**DESERT TORTOISE COUNCIL**

RE: Redonda Solar Project Public Scoping (DOI-BLM-CA-D060-2025-0014-EA)

### **Comments on the Proposed Project and Recommendations for the NEPA Document and Mitigation Plans**

Figure 1. Location of proposed Redonda Solar Project and gen-tie line and nearby development.

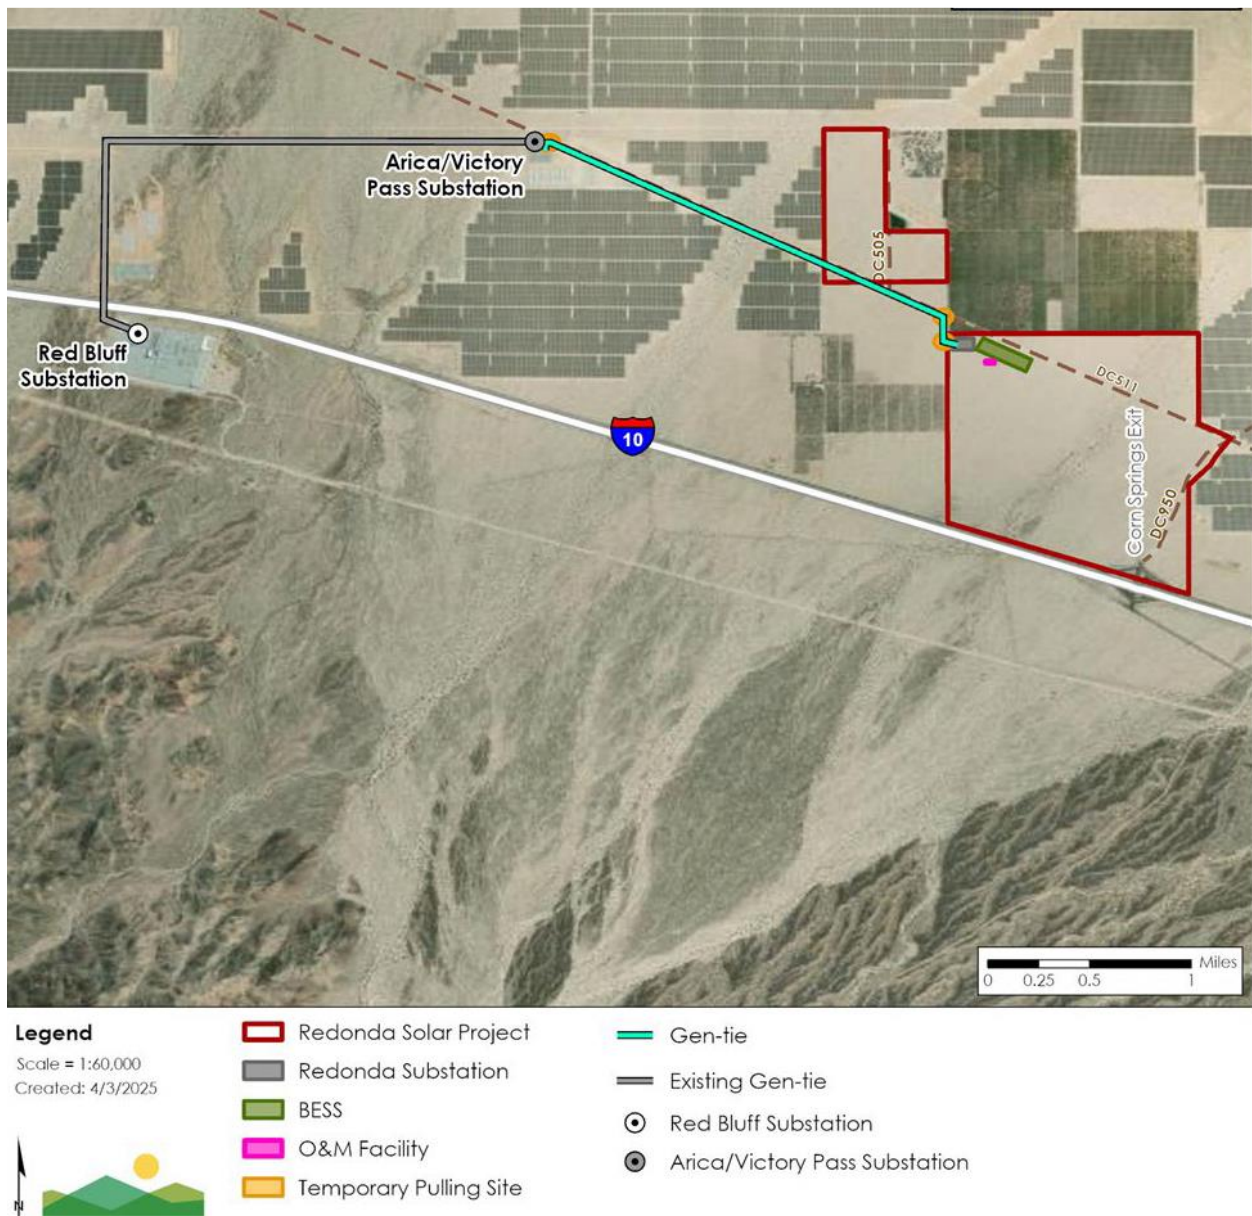
The project is approximately 8 miles east of the unincorporated community of Desert Center. BLM Open Routes DC 511 and DC 950 run through the project area and would remain open. The southeast project area is bordered by a solar project and undeveloped land on the west and east sides, agricultural development on the north side, and I-10 on the south side. The northwest project area is bordered by undeveloped land and a nearby solar project or agricultural development on the north, east, and south sides and a solar project and proposed gen-tie line on the west side (Figure 1).

Figure 2. Location of proposed Redonda Solar Project and tortoise critical habitat/Tortoise Conservation Area/BLM Area of Critical Environmental Concern for the Mojave desert tortoise.

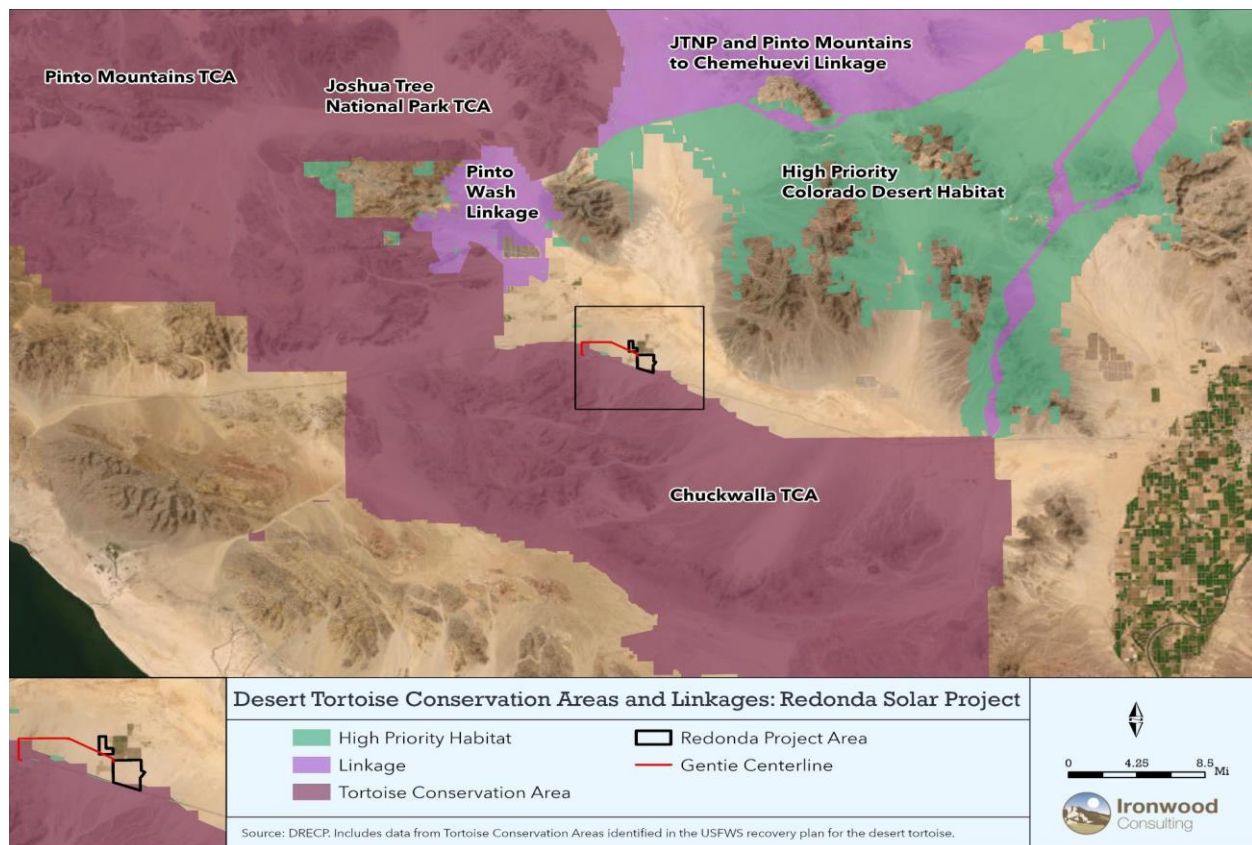
The project site is located within the Colorado Desert Recovery Unit for Mojave desert tortoise. The southern portion of the westernmost project area overlaps with the Chuckwalla critical habitat unit for the tortoise/Chuckwalla Tortoise Conservation Area (Figure 2).

Figure 3. Location of proposed Redonda Solar Project and vegetation communities including dry washes.

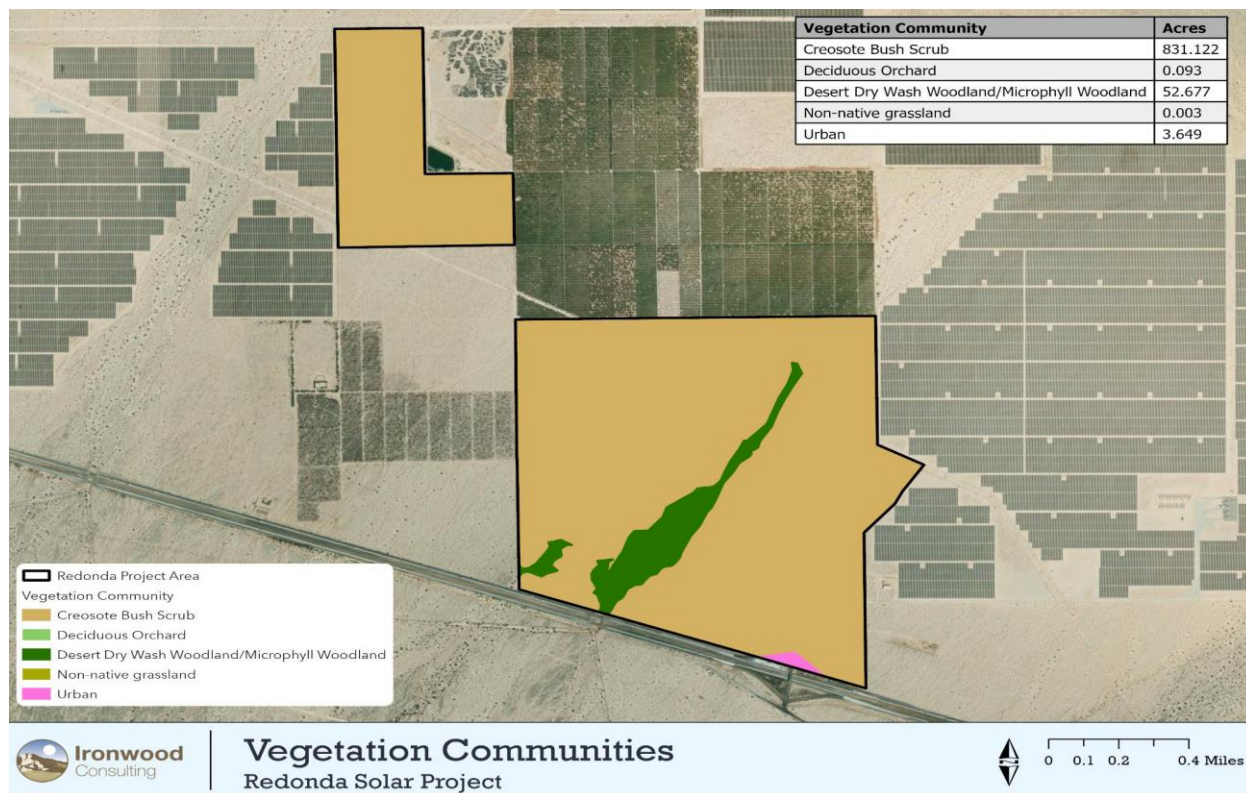
From the information provided in the Plan of Operations and the Biological Resources Technical Report, some of the designated critical habitat for the tortoise/TCA may be down-gradient from the project site (Figure 3). Please ensure that this analysis and mitigation to avoid these impacts to the tortoise/tortoise habitat is included in the NEPA document.

Figure 5. Locations of proposed Redonda Solar Project and other solar projects in this BLM Development Focus Area.

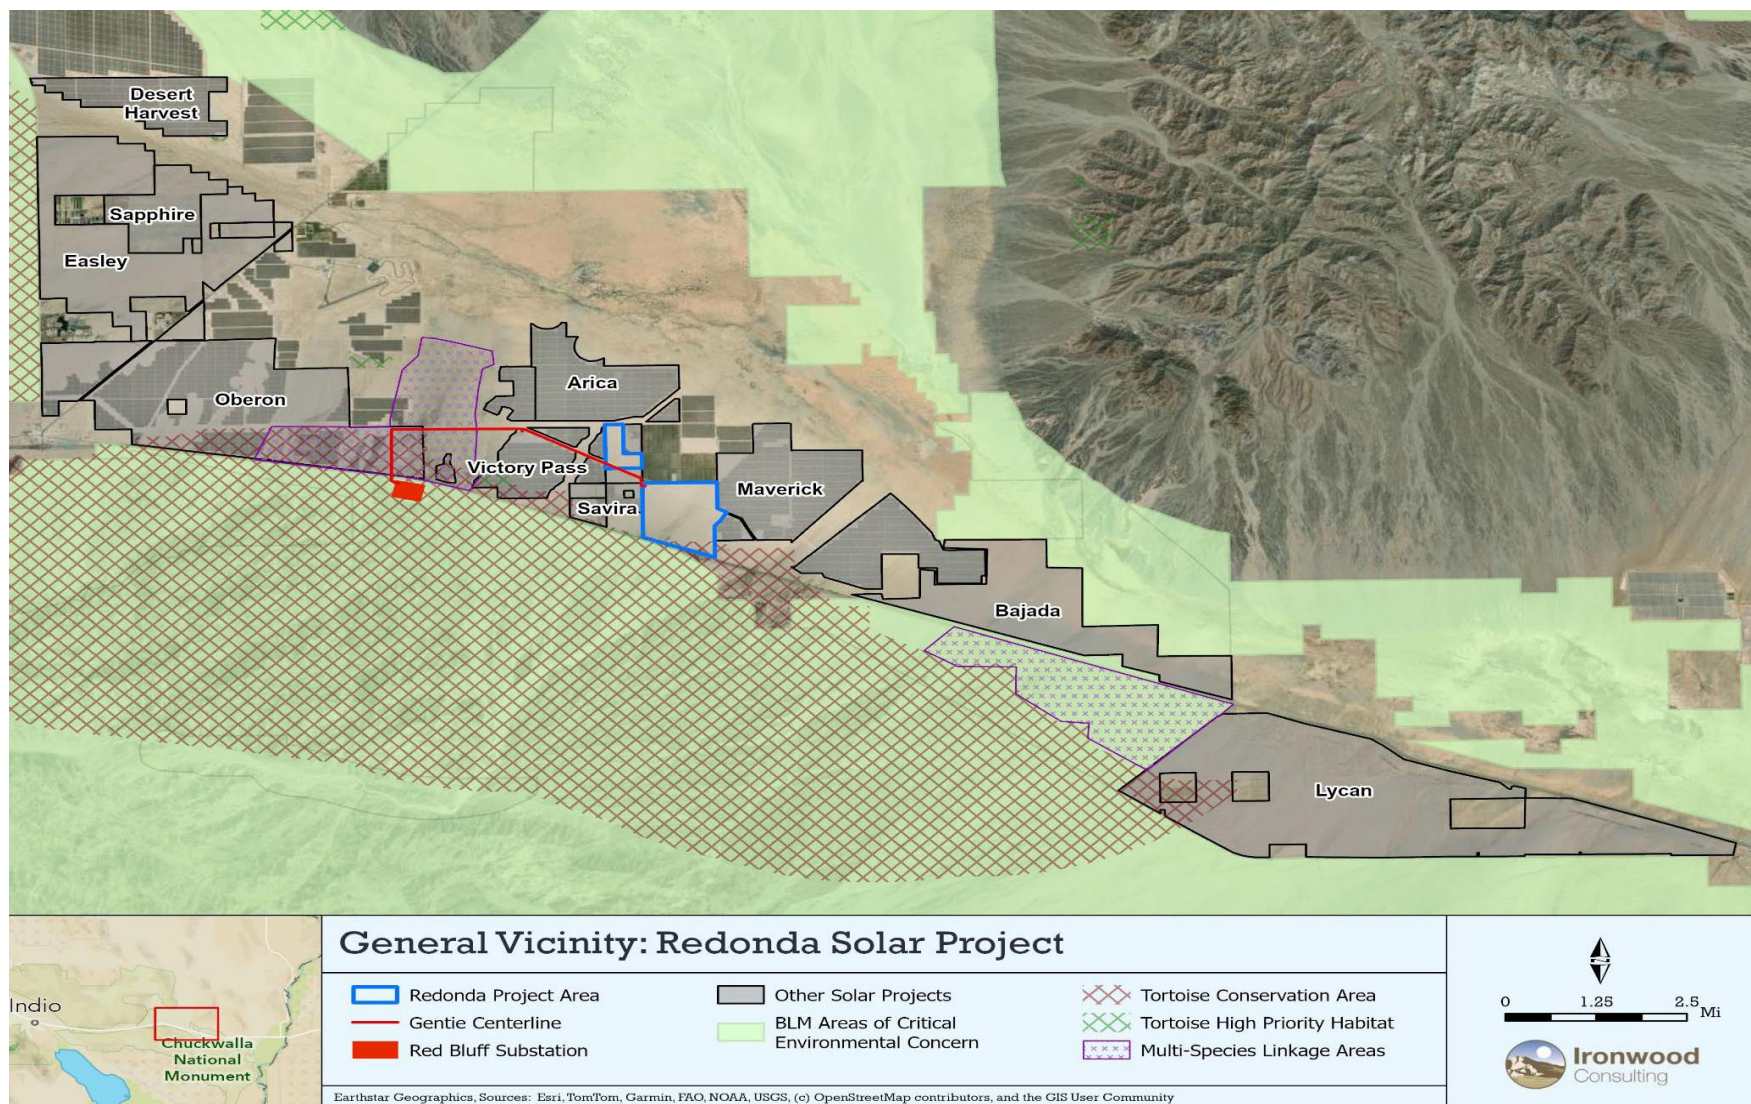
From a statistical perspective, these statements are correct. However, the proposed project is in a DFA with other solar projects located nearby and in tortoise habitat (Figure 5). If tortoises are translocated from several solar projects to the same recipient site, then we expect that USFWS would require BLM to conduct monitoring. Therefore, we request that this document provide relevant information on this issue, that is, information on the number of tortoises that have been removed from this DFA and the locations(s) where they have been moved. If the recipient locations are the same or adjacent and the number of tortoises sufficient to provide statistical analysis, then we request that the translocation plan be amended to require monitoring of the resident and translocated tortoises and tortoises at a control site.
